FS101-09/10-PART II

1703.5.4 (New)

PART II- IBC STRUCTURAL

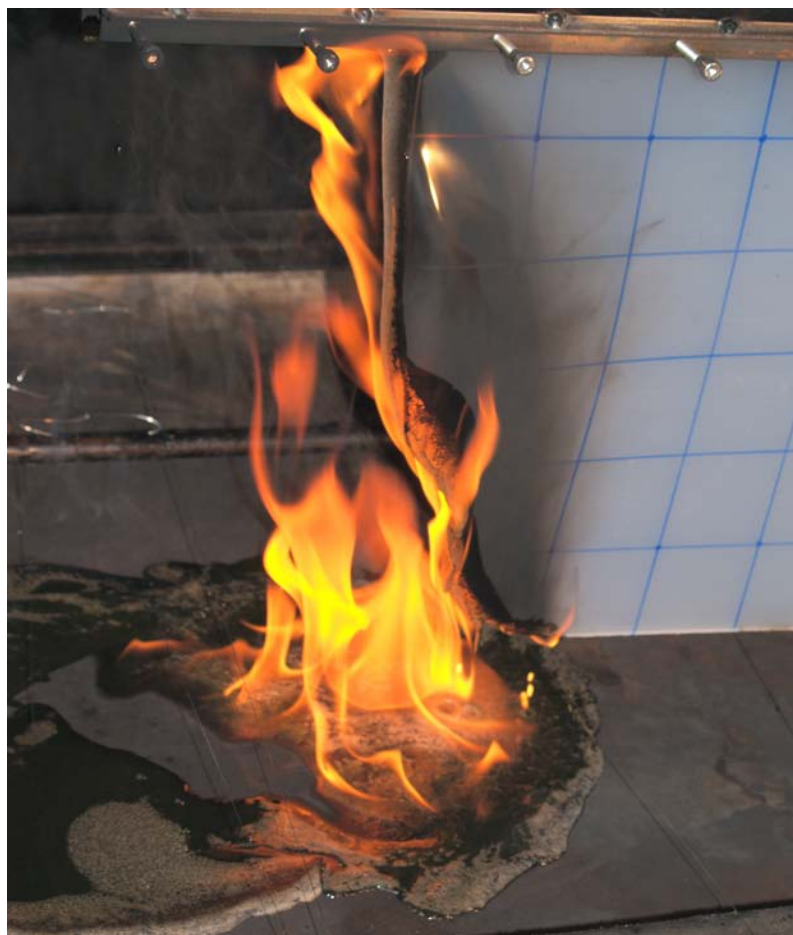
It is possible to make properly flame retarded polypropylene and use it for siding because flame retarded polypropylene can easily be compounded so that it does not melt/drip and pass the requirements of a flame spread index of 200 in the ASTM E 84 test. In fact, the original proposal includes an ASTM E 84 test with an FR polypropylene material that gave a flame spread index of 50. Such a material should be permitted for use but not the unsafe material normally offered for sale.

The missing Figure from the proposal (that could also be found with proposal RB148) is found below. It shows what happens when normal non flame retarded polypropylene (the material that is used in siding) burns: it forms a pool fire. The photograph is not polypropylene siding but its component material.
